Public Input No. 207-NFPA 70-2019 [Global Input]

"no less than"
change to
"not less than"

Public Input No. 259-NFPA 70-2020 [Global Input]

Figure 450.4(A) Autotransformer.

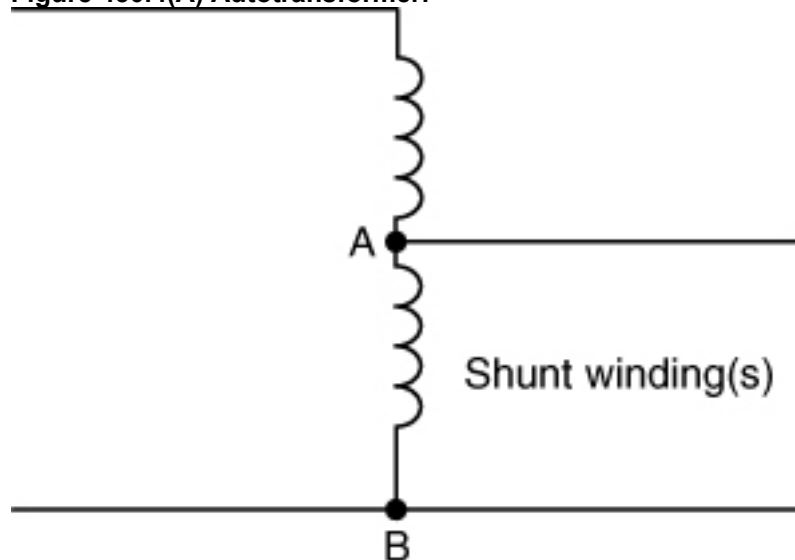
(A) Overcurrent Protection. Each autotransformer 1000 volts, nominal, or less shall be protected by an individual overcurrent device installed in series with each ungrounded input conductor. Such overcurrent device shall be rated or set at not more than 125 percent of the rated full-load input current of the autotransformer. Where this calculation does not correspond to a standard rating of a fuse or nonadjustable circuit breaker and the rated input current is 9 amperes or more, the next higher standard rating described in [240.6](#) shall be permitted. An overcurrent device shall not be installed in series with the shunt winding (the winding common to both the input and the output circuits) of the autotransformer between Points A and B as shown in [Figure 450.4\(A\)](#).
